Access Compliance Report

Intersection ID: 5889	Main Street: UNIVERSITY_CITY_BV	Cross Street: SUTHER_RD	Location: SE
ADA ID: 20110262E758	Ramp Type: Perp	Initial Pass/Fail: Pass	Overall Compliance: No
Codes/Mitigation Info/Possible Solution			Severity Score: 10
			Field Measurements/Component Compliance

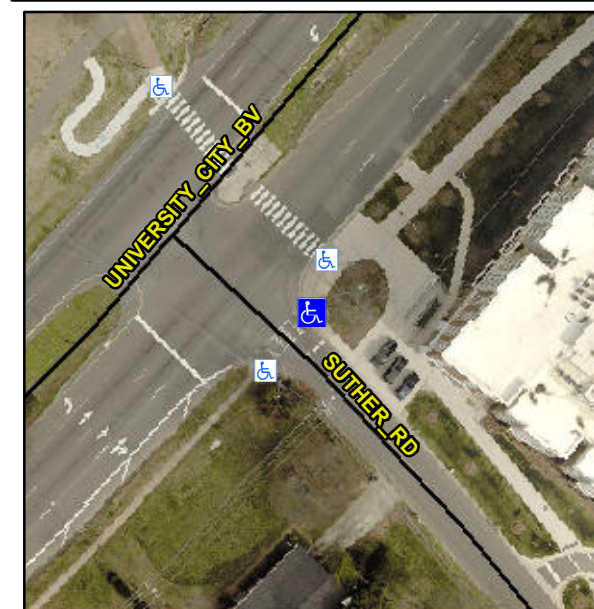
R304.2.1, R304.2.2-Perp, R304.3.2-Para, R304.5.3, R305.2

Compliance	Description	Data	Compliance	Description	Data
N/A	Ramp Length (in)	82.0	Yes	Ramp Slope (%)	6.8
Yes	Ramp Width (in)	48.0	Yes	Ramp XSlope (%)	1.2
N/A	Flare Type LT	Sloped	N/A	Flare Type RT	N/A
N/A	Flare Slope LT (%)	5.1	Yes	Flare Slope RT (%)	8.3
N/A	Flare Traversable LT?	Yes	N/A	Flare Traversable RT?	Yes
No	Landing Length (in)	N/A	Yes	DWS Provided?	Yes
No	Landing Width (in)	N/A	Yes	DWS Contrast?	Yes
No	Landing Slope (%)	N/A	Yes	DWS Length (in)	24.0
No	Landing X Slope (%)	N/A	Yes	DWS Full Width?	Yes
N/A	Landing Curb? (Y/N)	No	No	DWS Offset (in)	5.0
N/A	Shared Landing?	No			
Yes	Gutter Ponding?	No	Yes	Gutter Slope (%)	0.0
Yes	Gutter Lip Ht (in)	0.0	Yes	Gutter X Slope (%)	2.0
N/A	Painted X Walk1?	Yes	N/A	Painted X Walk2?	N/A
	X Walk 1 Direction	To SW		X Walk 2 Direction	N/A
N/A	X Walk 1 Width (in)	104.0	N/A	X Walk 2 Width (in)	N/A
	X Walk 1 Slope (%)	1.1		X Walk 2 Slope (%)	N/A
	X Walk 1 X Slope (%)	3.5		X Walk 2 X Slope (%)	N/A

Remove & Replace Entire Ramp.
